**Pre-Filed Testimony of
Edward Kavazanjian, Jr., Ph.D., P.E.**

**Submitted on behalf of Appellant
Airport Communities Coalition**

PCHB No. 01-160

ACC & CASE v. Dept. of Ecology & Port of Seattle

FLAC Model Deformation Analysis for a West MSE Wall Section

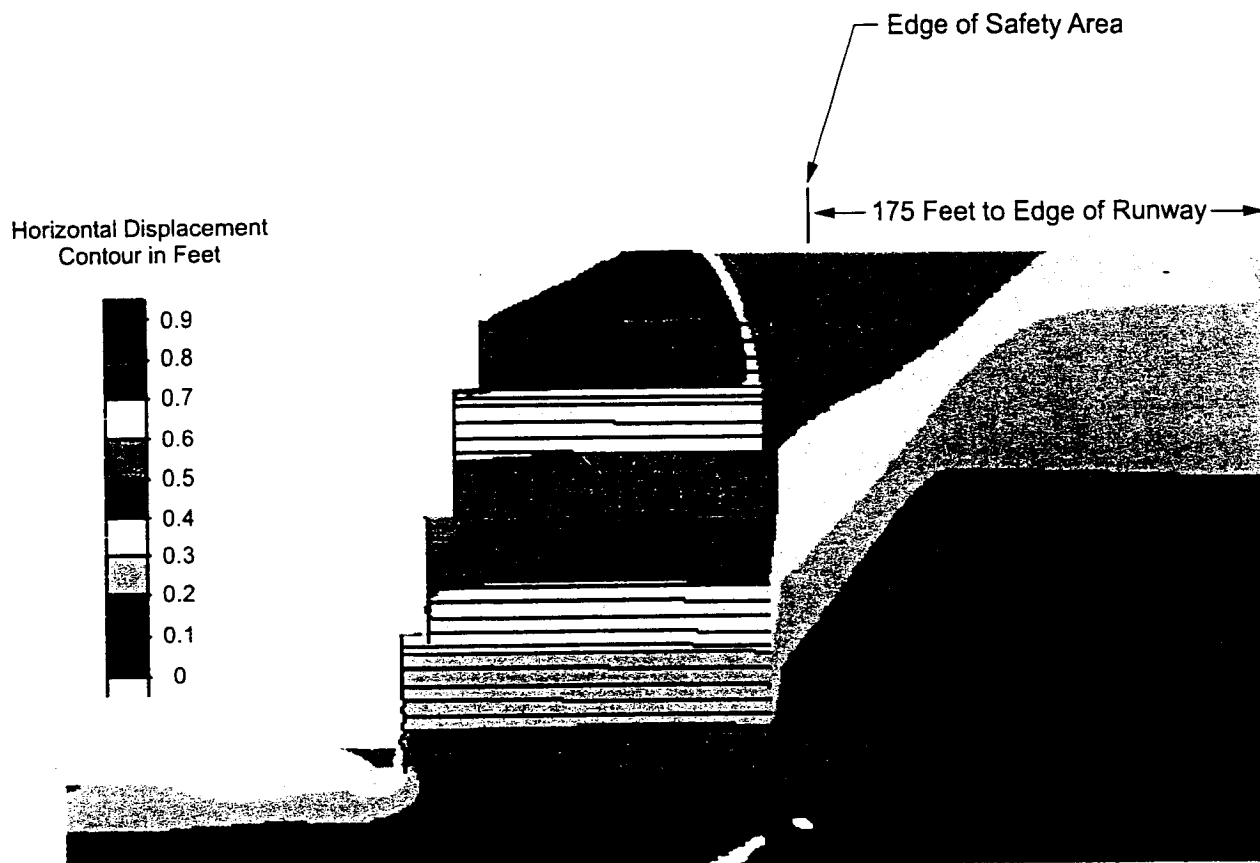
to calculate the seismic response of reinforced earth structures (e.g., MSE walls). FLAC provides the user with the option of employing a variety of different sophisticated and complex constitutive models and elements to model soil, reinforcing materials, and facing panels for MSE walls. Users may also install their own material models and elements within FLAC. However, sophistication and complexity do not in and of themselves ensure that a numerical model produces accurate and reliable results. In fact, the more sophisticated and complex a model is, the more sensitive the results of analyses made using the model are likely to be to discretionary choices made in the analysis. While the raw input data for some of the Port's FLAC analyses have recently been provided to us, no report has been produced explaining the analysis and the reasons for the discretionary choices. It is a difficult and laborious process to discern these discretionary choices from the FLAC input data. Furthermore, the Port has failed to provide any insight into the logic behind these discretionary choices. Considering their importance to the design of the West MSE wall, a detailed discussion of the Port's FLAC analyses, including the discretionary choices made in developing the numerical model and interpretation of the results of the analyses, should be provided for public review and comment in the form of a report.

The Port's Geotechnical Summary Report cites a series of papers from the technical literature as evidence that FLAC produces reliable and accurate results. However, most of these papers describe FLAC analyses of unreinforced earthen embankments. It cannot be assumed the West MSE wall FLAC analyses performed by Hart Crowser produce reliable and accurate results simply because previous investigators have reported that, if properly employed, FLAC can provide reliable results, particularly if these previous investigators have not considered earth reinforcement in their FLAC analyses. For a model as complex and sophisticated as FLAC, in

The need for benchmarking of a numerical model is particularly acute when previous analyses using the subject numerical model either have only shown that the model is capable of predicting “earthquake-like” patterns of behavior (rather than actual earthquake response) or have not employed all of the model features that will be required for the design analyses. Both of these limiting conditions hold true for the FLAC analyses of the West MSE wall. Most of the FLAC analyses cited by the Port’s consultant as evidence of the reliability of the FLAC analyses involve unreinforced earthen embankments (e.g., Inel, et al., 1993; Roth et al., 1993; Makdisi, et al., 2000). The comparisons between observed and predicted behavior presented in these papers on unreinforced earthen embankment are limited in scope and show only general agreement between calculated and observed seismic response. Furthermore, several of these investigators (Roth, et al., Makdisi, et al.) use “customized” soil models that are not available in the commercial version of FLAC. The papers that describe FLAC analyses of MSE walls (Bathurst and Hatami, 1998 and 1999) describe numerical analyses only and make no comparisons with either field or model seismic performance. In light of the limited comparisons between FLAC predictions and the observed seismic behavior of unreinforced earthen embankments and in the absence of any comparisons between FLAC predictions and the observed seismic behavior of MSE walls, the ability of FLAC to reliably evaluate the performance of the West MSE wall is unverified and must be considered unproven. The need for verification of FLAC was noted by

Bathurst and Hatami (1999), who caution in their Conclusion that “Finally, at the time of this paper, the results of FLAC models of the type reported here have not been calibrated against any physical models.” These authors go on to note that “physical data that can be used to guide the selection of appropriate modeling parameters, such as damping ratio, are necessary to confirm that the results of FLAC modeling are accurate.” Without this type of confirmation based upon physical data, FLAC analyses cannot be considered to provide reasonable assurance that the West MSE wall can resist the design seismic loads.

Figure 12 shows an example of the maximum horizontal displacement calculated for preliminary analysis of a representative section of the west MSE wall. The displacement contours indicate that the top of the wall would have a permanent displacement of about 10 inches resulting from the earthquake design motion (discussed below). The calculated vertical deformations are much less than the horizontal displacement. Another part of this same analysis provides designers with a tabulation of the maximum stress in the MSE reinforcing strips used in this section (see for example Hart Crowser 2001g).

Figure 1: Hypothetical Seismic Stability Failure Surface

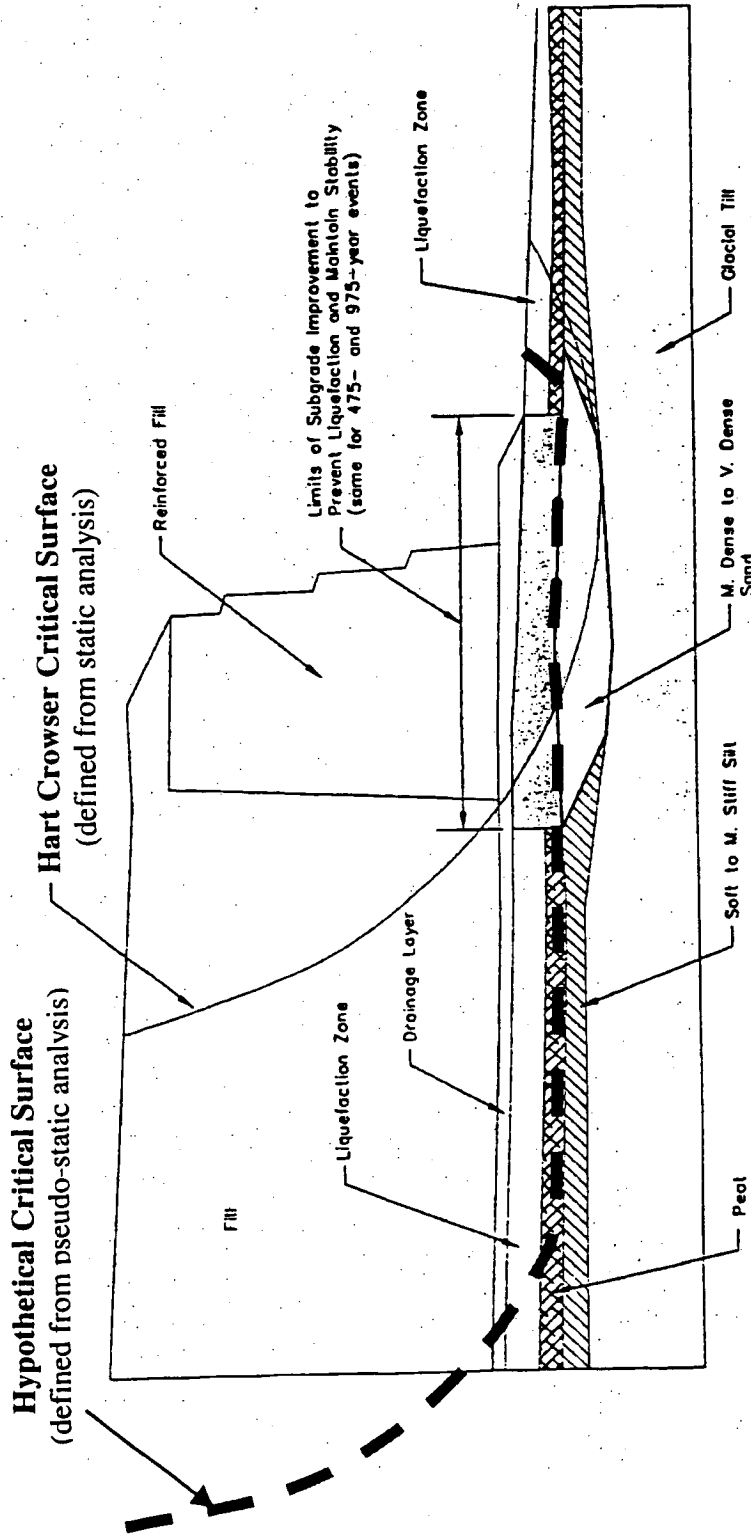
Figure 1 shows a conceptual sketch of a representative failure surface under pseudo-static conditions, extending through the weak peat layer far back into the fill (and potentially beyond the limits of the modeled cross-section). As currently analyzed and designed only the weak soils directly below the wall are being improved. If the critical seismic failure surface extends along the weak peat layer or liquefied zone farther back into the embankment than the static surface, the areas for ground improvement will also need to extend further back in order to remove the threat of these weak soils under a strong earthquake.

HARTGROWSER
 J-4878-08 03/01
 Figure 3

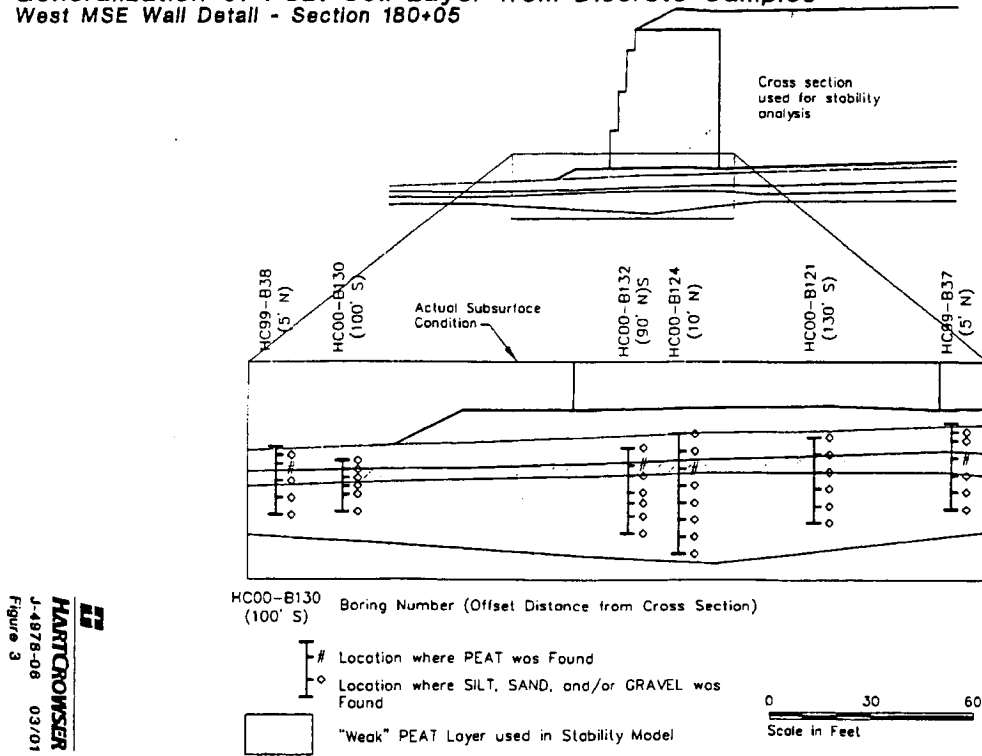
The comment asserts that the Port's pseudo-static (seismic) stability analysis is improper, and that a more "proper" analysis should be performed to search for the critical failure surface independently of the static analysis. However, it is the Port's belief that there is no theoretical justification, or code requirement that justifies the suggested approach. The pseudo-static approach used by the Port represents the standard of practice for this type of analysis. Searching for a critical surface with the pseudo-static acceleration

The comment goes on to say that "sliding block" type failure surfaces should be considered in the analysis. The Port's design team did utilize sliding block or irregular surface analyses, (as described in the reports: Hart Crowser, 2000. "Preliminary Stability and Settlement Analyses, Subgrade Improvements, MSE Wall Support, Third Runway Project", Appendix A June 2000; and Hart Crowser, 2000. "Stability Review of RECo 30 % Design - Third Runway Project," Hart Crowser Memorandum, November 9, 2000, (i.e. analysis attachment pages 3, 6, 10 A & B, 11, 15, 17, 20, 28, and 40 through 42). The reported factors of safety for design include both circular and sliding block (or irregular wedge) type potential failure surfaces.

The Port recognizes that there are inherent limitations in the use of any pseudo-static, limit equilibrium type analysis to assess stability of slopes and MSE walls. The Port's engineers have addressed seismic stability recognizing the limitations in the pseudo-static method through the use of appropriate design parameters and factors of safety; use of post-liquefaction stability analyses, and in part by using a completely different approach (finite difference based deformation analysis) to provide an independent assessment of seismic stability.

Not only did the Port's analyses include analysis of the sliding block type failure mode, many of its analyses included an artificially extended weak seam to verify that such a layer would not cause instability. This type of generalization is illustrated in enclosed Figure 2 (previously discussed) and Figure 3. Figure 3 shows an example of how intermittent isolated zones of peat were conservatively generalized into a weak layer, for purposes of the stability analysis.

The proposed subgrade improvement zone below each MSE walls was designed to provide a stable buttress assuming that there could be some zones of liquefaction or other weak soils below the embankment that are outside the zone of subgrade improvement. The enclosed Figures 2 and 3 illustrate specifically how the Port's analysis considered the potential effect of weak layers (liquefaction-susceptible soils and peat respectively) extending beyond the limits of the modeled cross-section. Since the proposed subgrade improvement zones were sized to provide a stable buttress to the embankment under both static and seismic conditions, there is no threat of weak soils below the embankment causing instability of the MSE walls.
